# Access Compliance Report

## Public Rights-of-Way

### (Curb Ramps)

Intersection ID: 50203	Main Street: WEDDINGTON_RD	Cross Street: COLTSVIEW_LN	Location: SW
ADA ID: 22E05BC8253E	Ramp Type: BlendTrans1	Initial Pass/Fail: Fail	Overall Compliance: No
Severity Score: 8.75			
Codes/Mitigation Info/Possible Solution		Field Measurements/Component Compliance

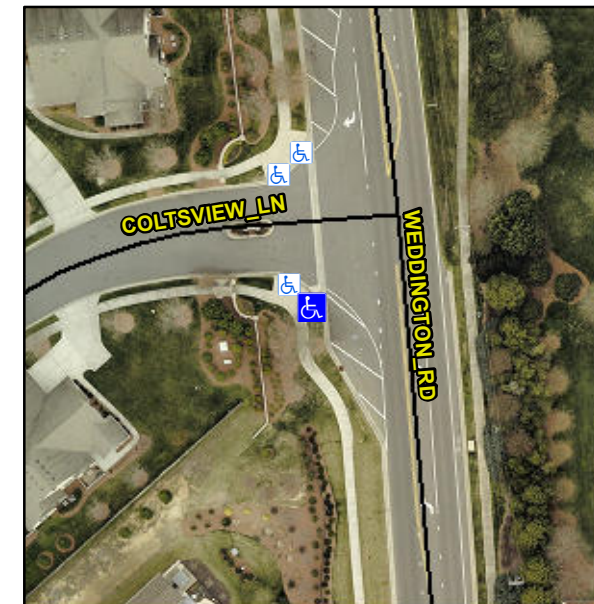
**Not Found, R304.5.1**

Compliance	Description	Data	Compliance	Description	Data
N/A	Ramp Length (in)	97.0	Yes	BlendTrans Slope (%)	4.6
No	Ramp Width (in)	47.5	Yes	BlendTrans XSlope (%)	0.0
N/A	Flare Type LT	N/A	N/A	Flare Type RT	N/A
N/A	Flare Slope LT (%)	N/A	N/A	Flare Slope RT (%)	N/A
N/A	Flare Traversable LT?	N/A	N/A	Flare Traversable RT?	N/A
N/A	Landing Length (in)	N/A	N/A	DWS Provided?	N/A
N/A	Landing Width (in)	N/A	N/A	DWS Contrast?	N/A
N/A	Landing Slope (%)	N/A	N/A	DWS Length (in)	N/A
N/A	Landing X Slope (%)	N/A	N/A	DWS Full Width?	N/A
N/A	Landing Curb? (Y/N)	N/A	N/A	DWS Offset (in)	N/A
N/A	Shared Landing?	N/A			
N/A	Gutter Ponding?	N/A	N/A	Gutter Slope (%)	N/A
N/A	Gutter Lip Ht (in)	N/A	N/A	Gutter X Slope (%)	N/A
N/A	Painted X Walk1?	No	N/A	Painted X Walk2?	N/A
	X Walk 1 Direction	To E		X Walk 2 Direction	N/A
	X Walk 1 Width (in)	N/A		X Walk 2 Width (in)	N/A
	X Walk 1 Slope (%)	0.2		X Walk 2 Slope (%)	N/A
	X Walk 1 X Slope (%)	1.8		X Walk 2 X Slope (%)	N/A

N/A	Ramp inside XWalk1?	N/A	N/A	Ramp inside XWalk2?	N/A
	Road Slope (%)	1.8		Clear Space?	N/A
	Road X Slope (%)	0.2	N/A	Clear Space to XWalk (in)	N/A
N/A	Any Obstructions?	N/A	N/A	Storm Grate/Utility Hazard?	N/A
	Obstruction Type			Storm Grate/Utility Type	
		N/A			N/A
			Yes	Surface Condition? (G/P)	Good
			No	Curb Slope (%)	10.3

**Remove & Replace Curb Ramp With Two New Directional Ramps or Equivalent.**
